BUILDING CODE OF AUSTRALIA 2022 ASSESSMENT REPORT

UPGRADES TO KINGSWOOD PUBLIC SCHOOL

46-54 SECOND AVENUE, KINGSWOOD, NSW 2747

Scope of Mark Up :
BCA Comments

1 PLAN
GROUND FLOOR
SCALE: 1:100

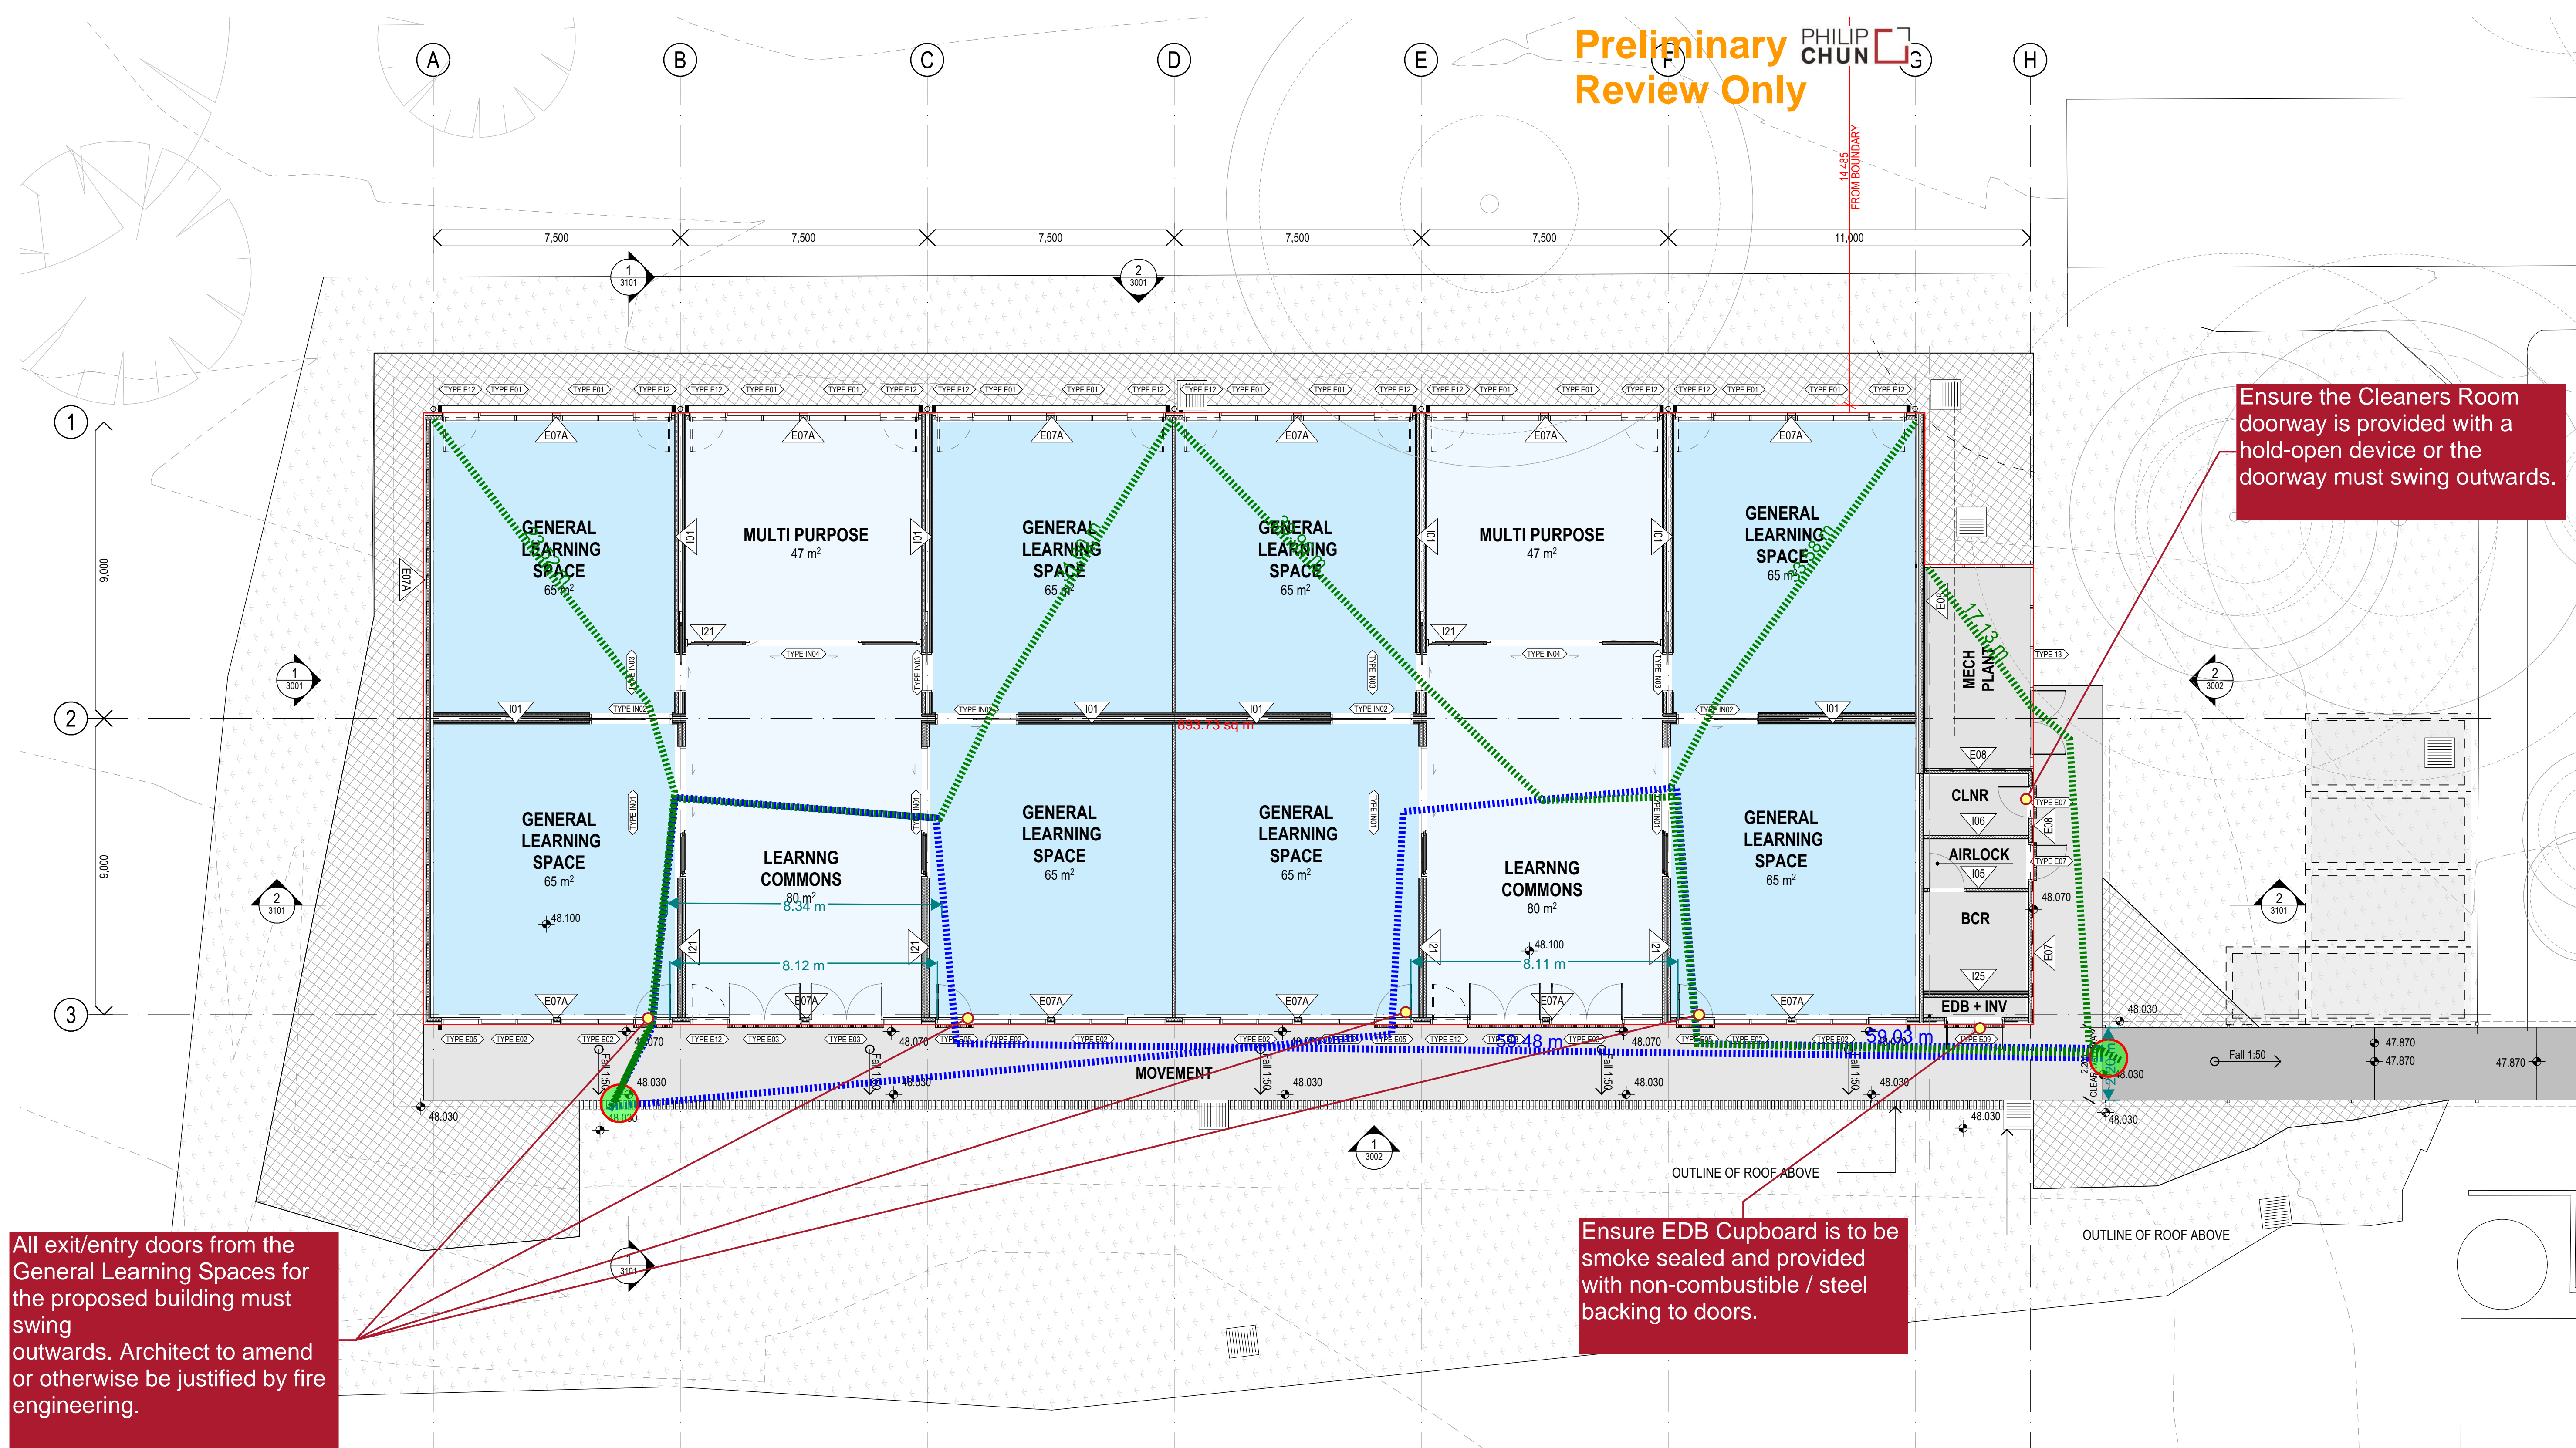
All exit/entry doors from the General Learning Spaces for the proposed building must swing outwards. Architect to amend or otherwise be justified by fire engineering.

Ensure EDB Cupboard is to be smoke sealed and provided with non-combustible / steel backing to doors.

Ensure the Cleaners Room doorway is provided with a hold-open device or the doorway must swing outwards.
